**City of Portland, Maine - Building or Use Permit Application**

Permit No: 02-0422	Issue Date: MAY - 3 2002	CBL: 141 F040001
-----------------------	-----------------------------	---------------------

**Proposed Project Description:**  
DEMO GARAGE addition of 16' x 12' screen porch & second story

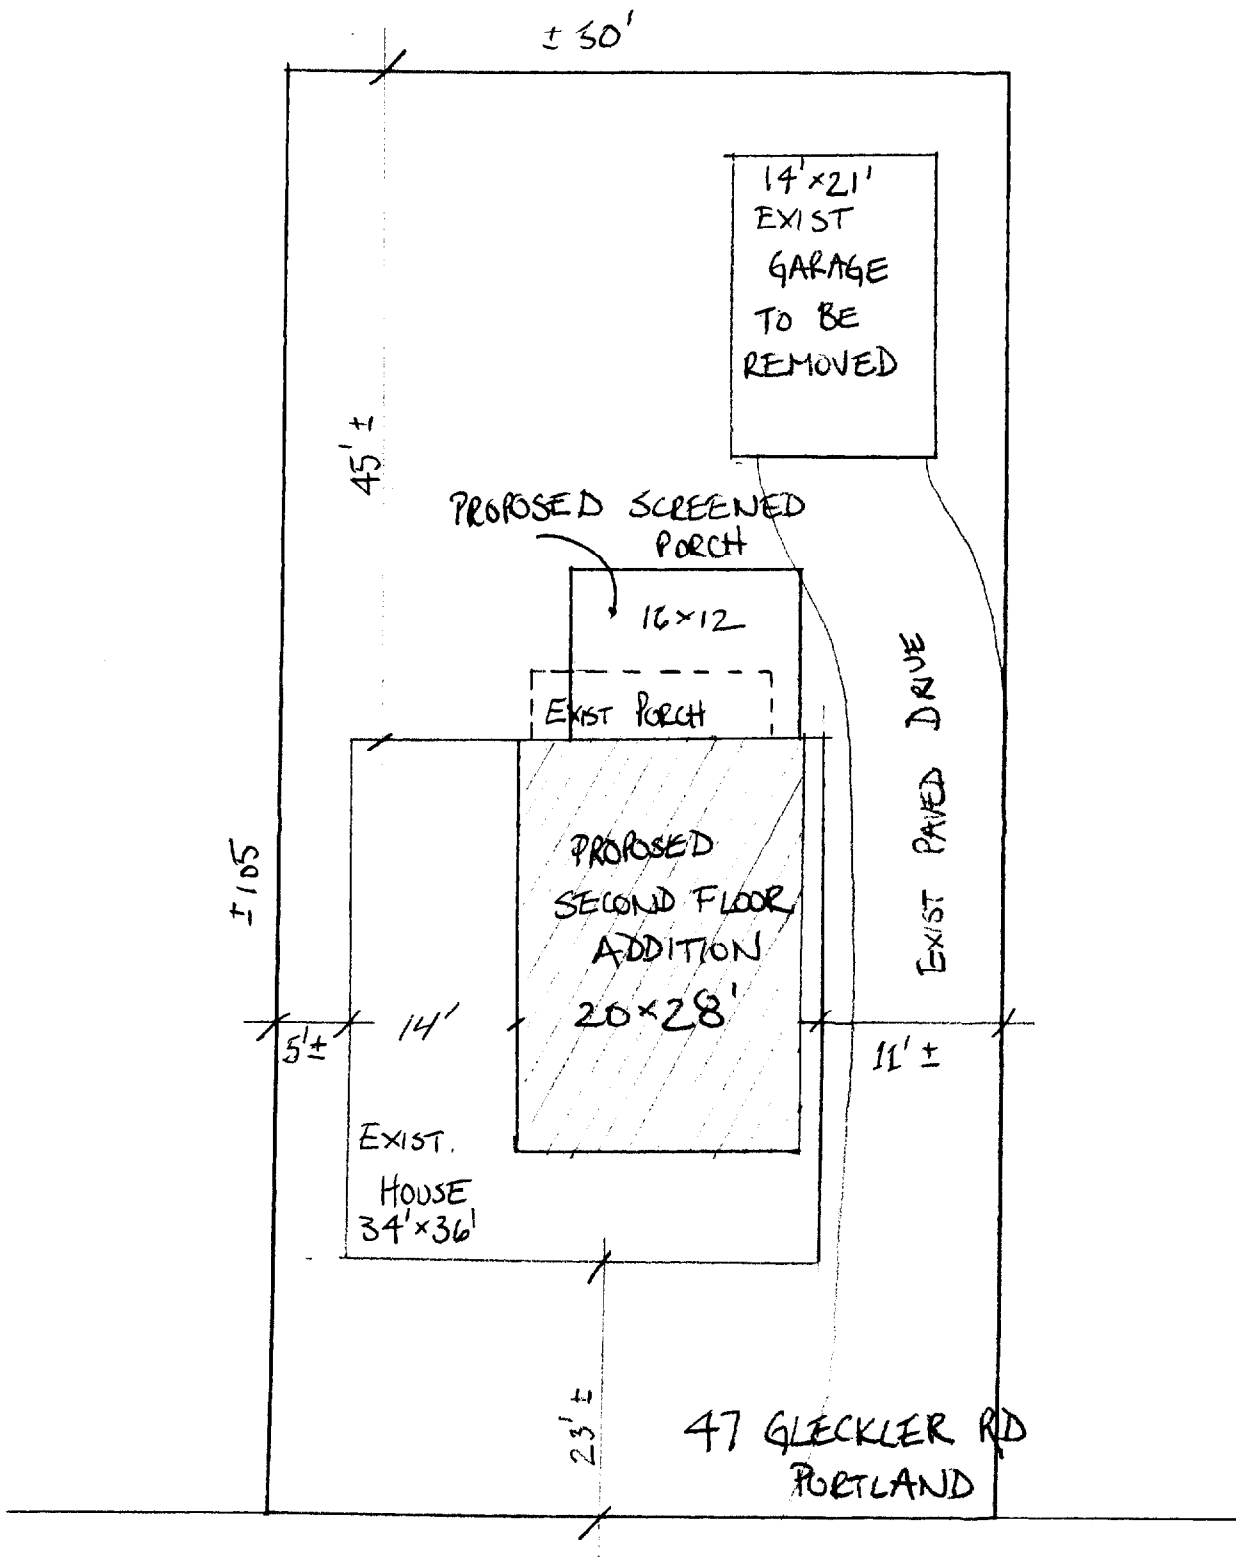
↑  
Reduces lot cov.  
more conforming

Section 14436 -  
Allows 50% of 1st  
floor = 612 SF →  
560 SF proposed -  
OK

Page # A1

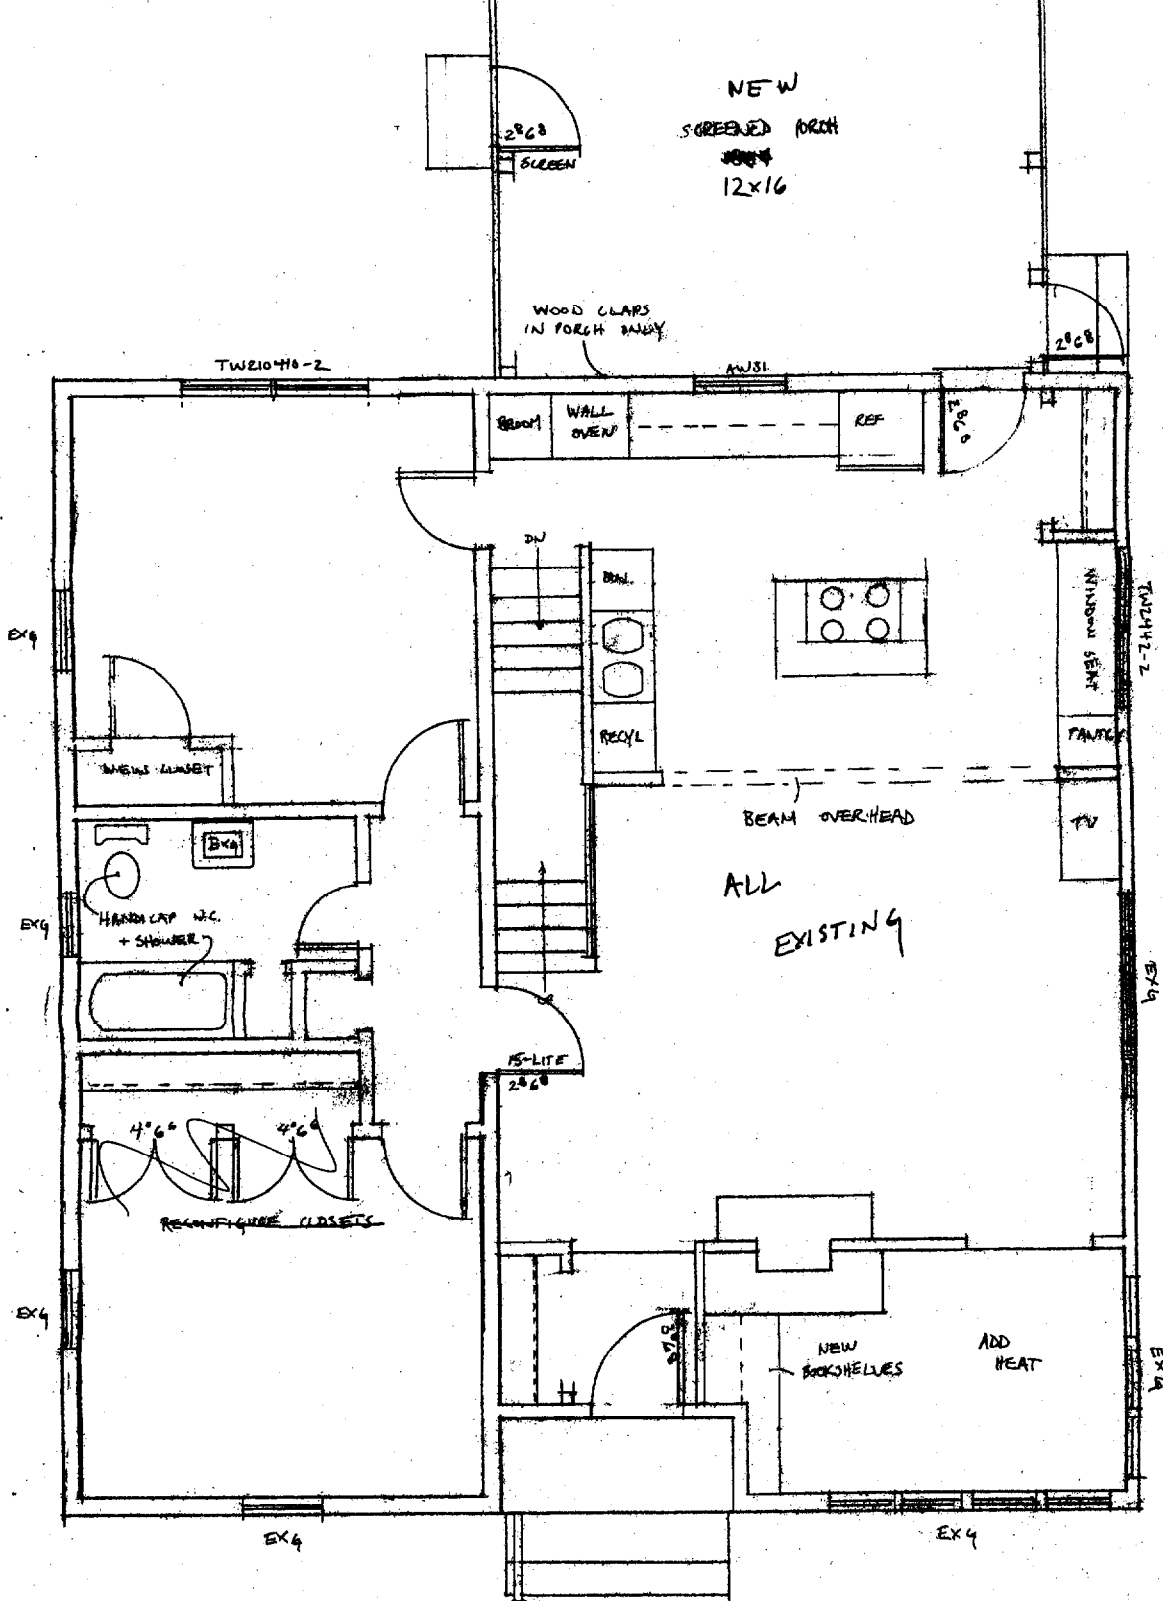
ADD HAND RAIL  
FIRST FLOOR

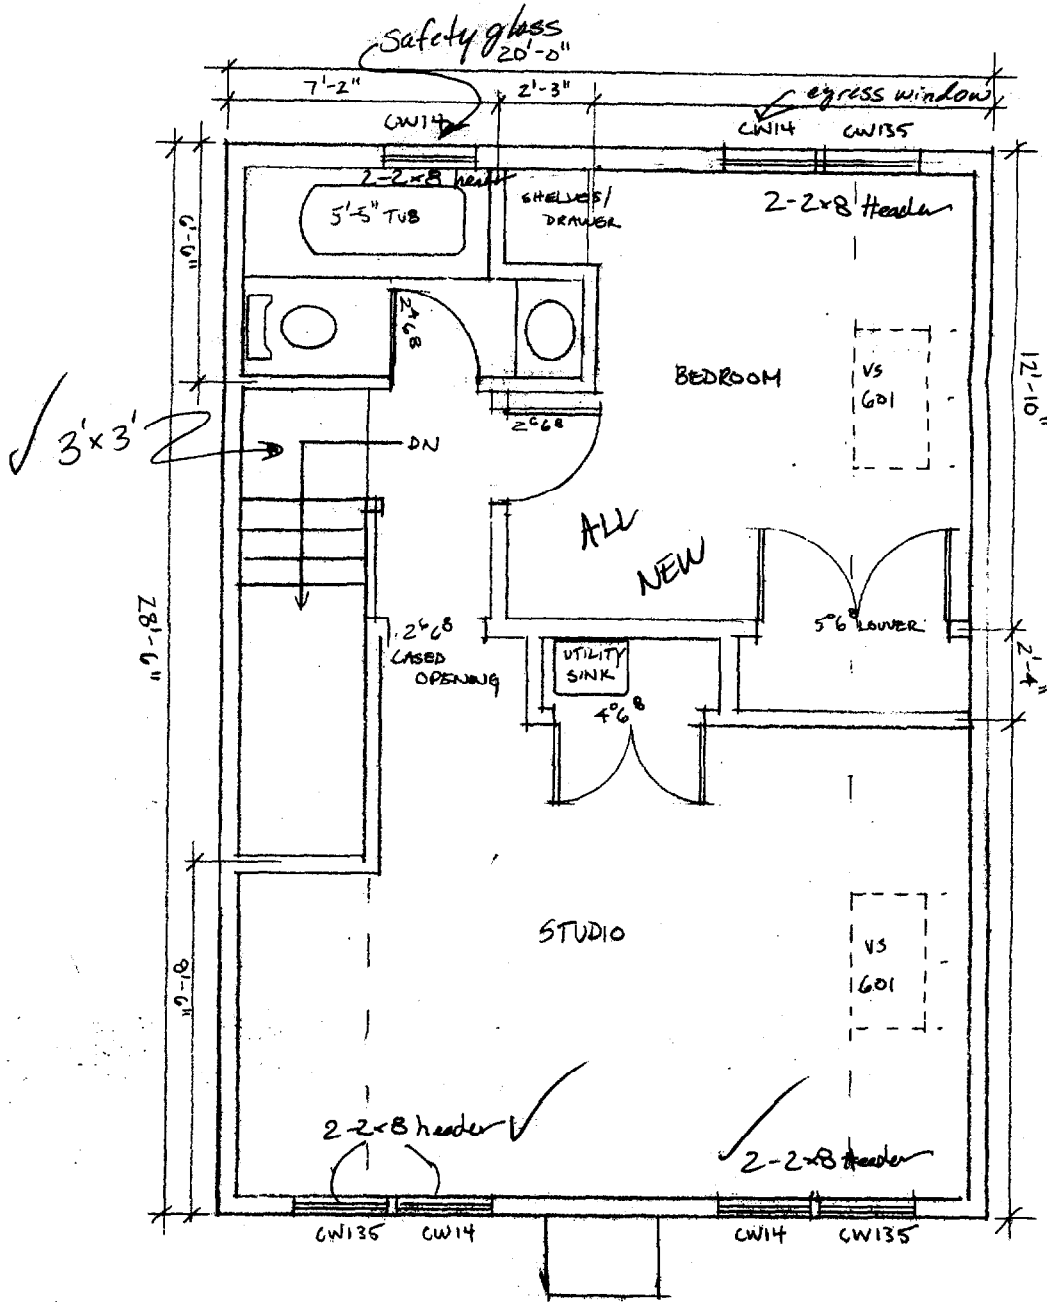
Smokes installed
